Notice of Allowability

10/718,234

In re Appln. of: Kronung Stefan, et al.
Appln. No. 10/718,234 filed November 20, 2003
For: System and Method for Preventing Rollover
Attorney Docket No.: 11721-037

2/4

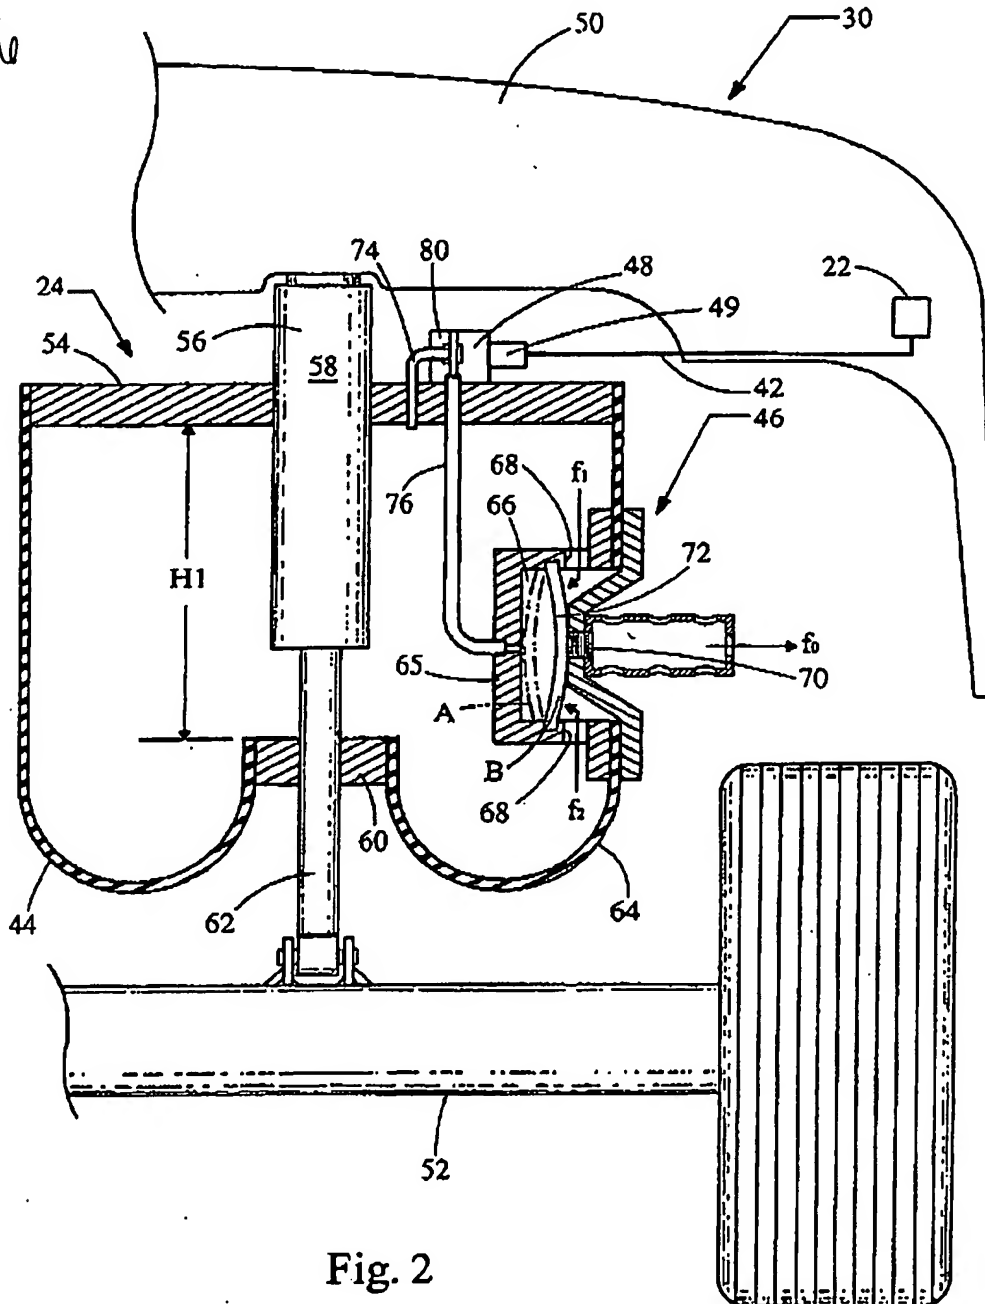
Claims 2 and 3 were each amended to add a block diagram represent air reservoir 49 and pyrotechnic device 80 (the proposed replacement sheets submitted by applicant on 6/30/06 were not approved by the examiner. These sheets would have resulted in new matter (there was no support in the original specification for the proposed locations of parts 49 and 80; modifications cannot be shown in the same figure according to 37 CFR 1.84h (5); the air reservoir where indicated would not have introduced air to the bladder 44, as the structure at 48 only moves the diaphragm plate to release air. Reference numeral 74 and its lead line were removed because that numeral is not discussed in the specification). In order to avoid abandonment of the application, applicant must make these above agreed upon drawing changes.
